IEEE P802.3at Task Force Power Via MDI Enhancements

Simultaneous Operation of ALT A and B
4P Adhoc

Suggested Remedy for all 4P comments

May - June 2008 Report
Yair Darshan

Figure 1-1

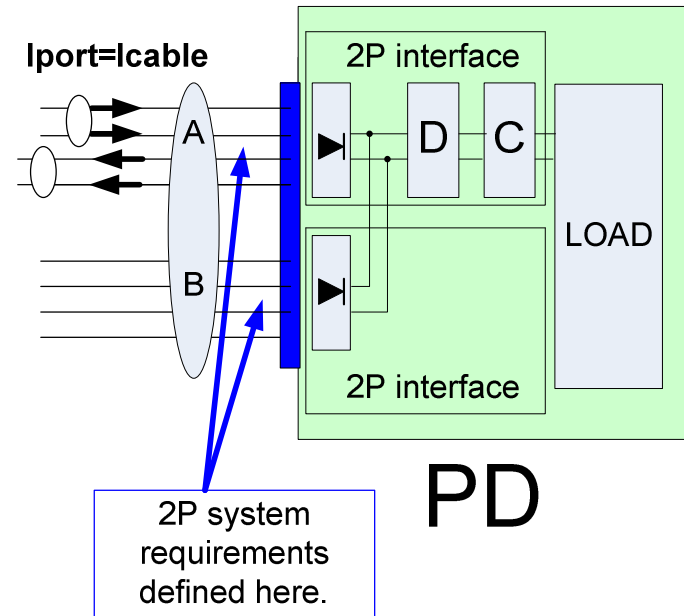
This PD is equivalent in power requirements to figure 1-1. The difference is different implementation.

However according to the current Figure text in the PSE, we can't deliver the 1-2 current over all 4 pairs.

This is what we allow today

Both PDs will work with any PSE (2P, 2x2P)

Adhoc agrees

Today We Can Do The Following....Figure 2

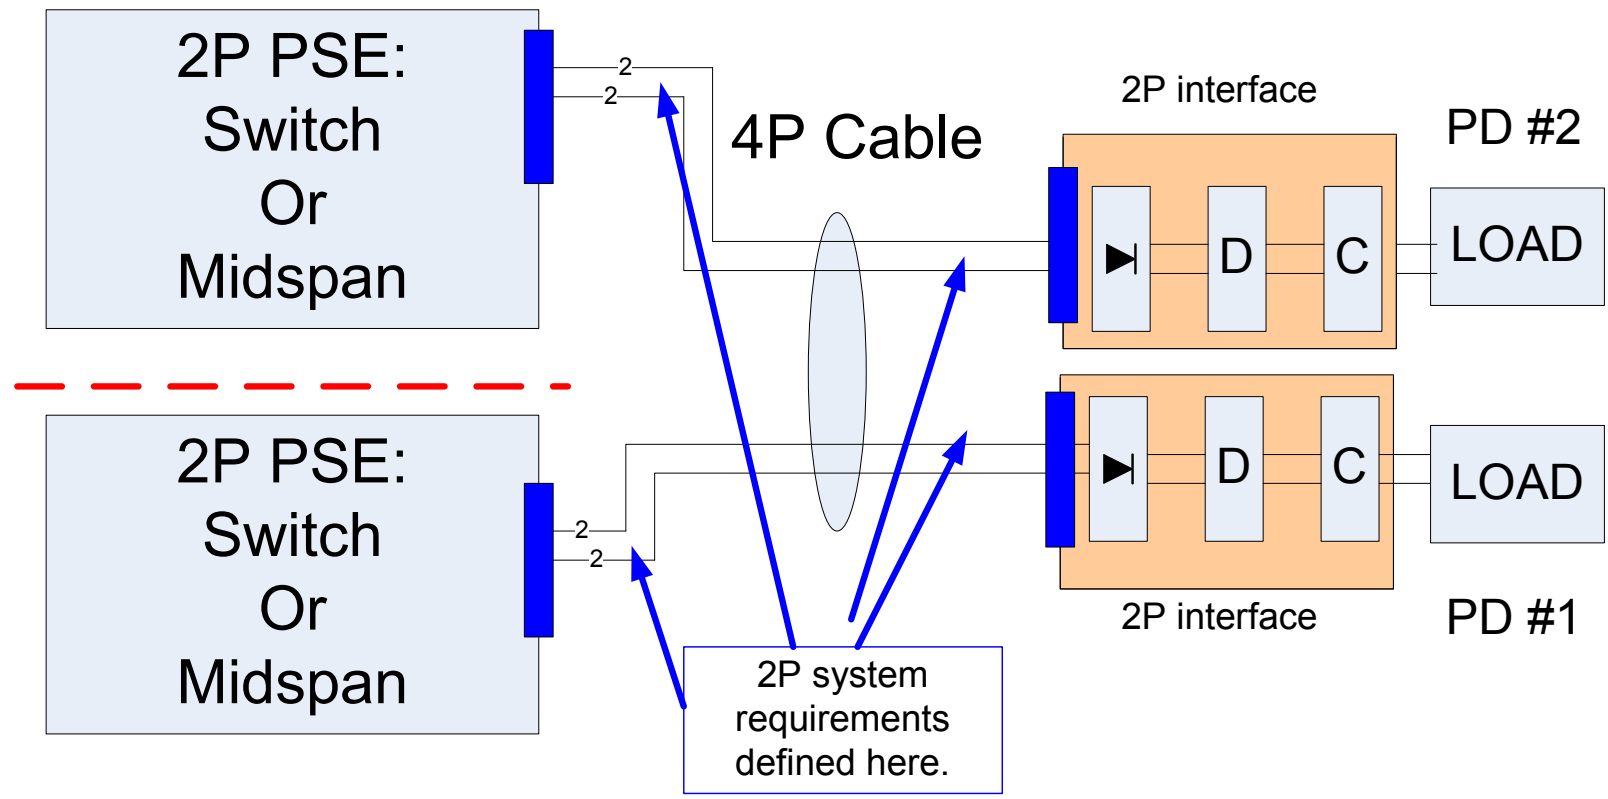
--- Environment A or B isolation as defined by IEEE802.3af
 ■ Connector. The 2 x 2P PSE may be located in the same or different box.

2 Cables. May be integrated to a single cables. All cables are simultaneously powered.

Adhoc agrees

The spec is not prohibiting Y connection – Figure 3

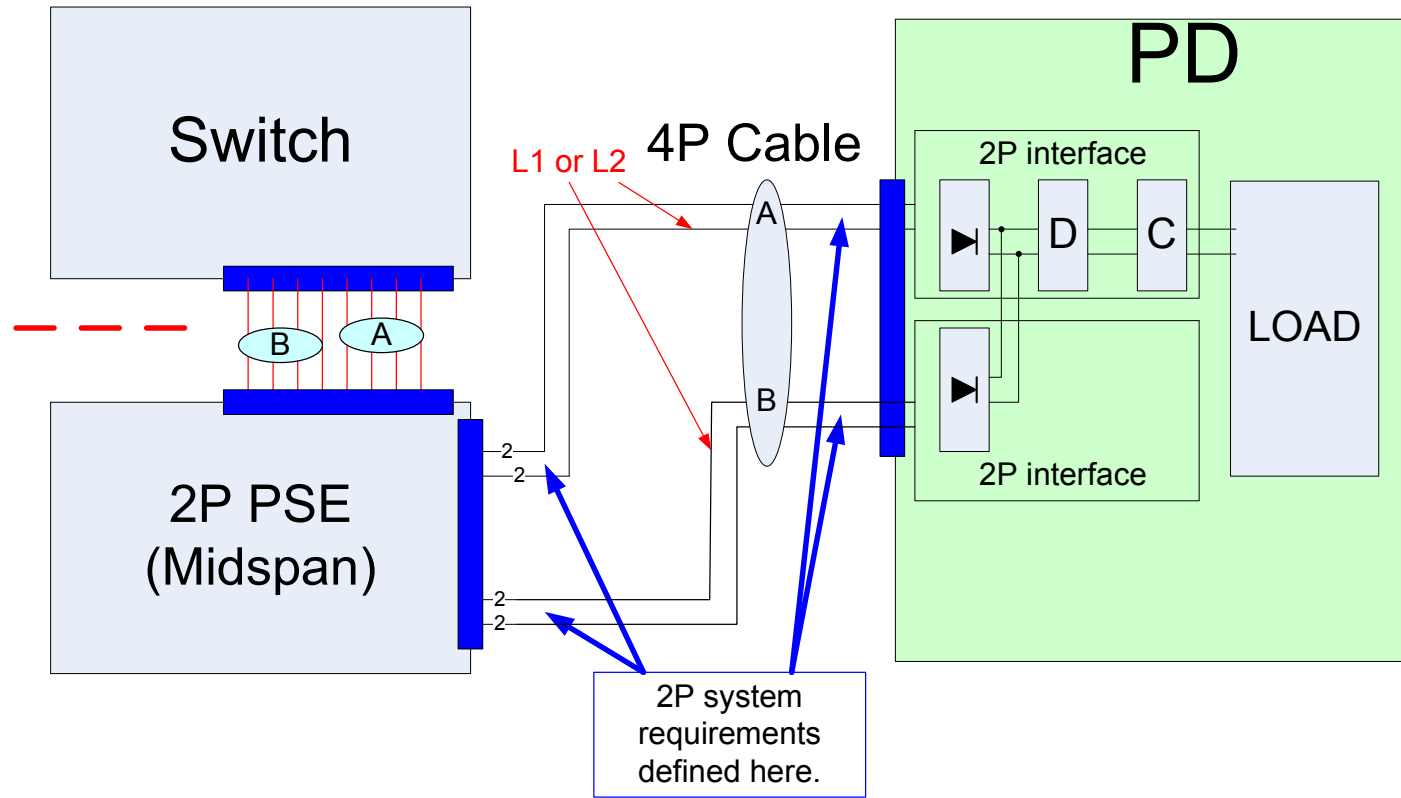
- - - Environment A or B isolation as defined by IEEE802.3af
- Connector. The 2 x 2P PSE may be located in the same or different box, on the same cable.

Simultaneous power all pairs.

Adhoc agrees
